# CAA Operational Assessment

Title of airspace change proposal	Manchester Low Level Route
Change sponsor	UK Civil Aviation Authority
Project reference	RCL-2024-001
Account Manager	[REDACTED]
Case study commencement date	12 September 2024
Case study report as at	5 November 2024

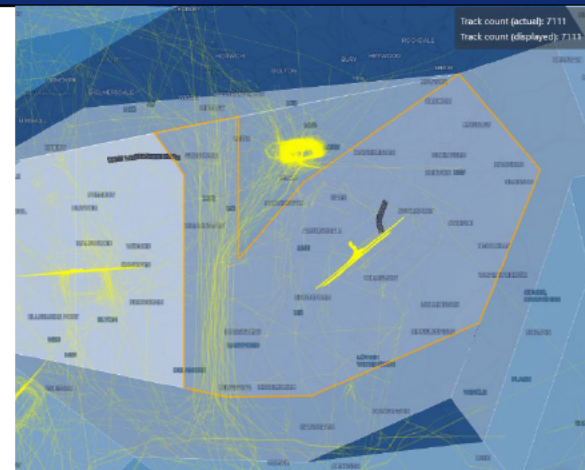
This is an Airspace Change Proposal conducted under CAP1991 (Procedure for the CAA to review the classification of airspace). It acknowledges that the extant Manchester Low Level Route (MLLR) exists and is regularly utilised by GA traffic (only by exception to the rules of Class D airspace). The trajectories shown on the left are 1 week of traffic using the MLLR in July 2024.
